CITY OF HAYWARD AGENDA REPORT

SUBJECT: **Zone Change No. PL-2003-0533 & Vesting Tentative Tract Map 7470/PL-2003-0534 –Trumark Companies (Applicant)/ The Domoto Family Partners LP (Owner) – Request to Change the Zoning From Agricultural (A) District to Planned Development (PD) District and Subdivide 5 Acres to Build 46 Homes**

The Project Location Is 26521 Whitman Street (former Domoto Nursery)

A-8

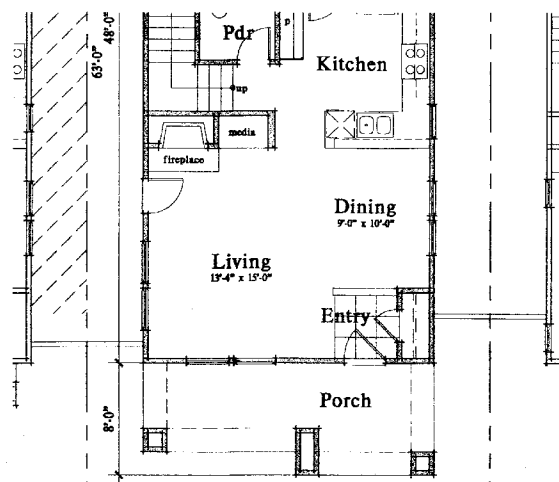
- k) Sheet A-8 shall be revised to show that railings will have a vertical wood design.
 - l) The site plan shall be revised to eliminate the house on Lot 41. The public street shall be adjusted so that additional area can be added to Lots 40, 42, 45 and 46.

Plan 1B Left Elevation
LOT 1

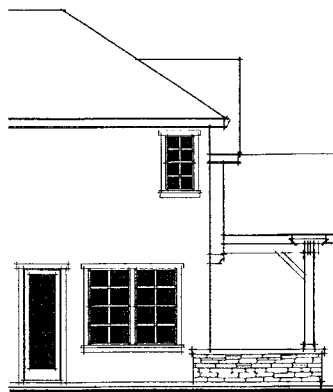
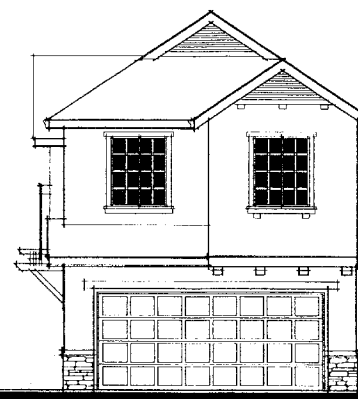
- i) Lot 1 floor plan shall be revised to show the utility meters on the opposite side of the garage so that they do not conflict with gate access.
 - j) Elevations having stone work across the lower portion of a front elevation shall be revised to show the stone wrapping all the way around the house.
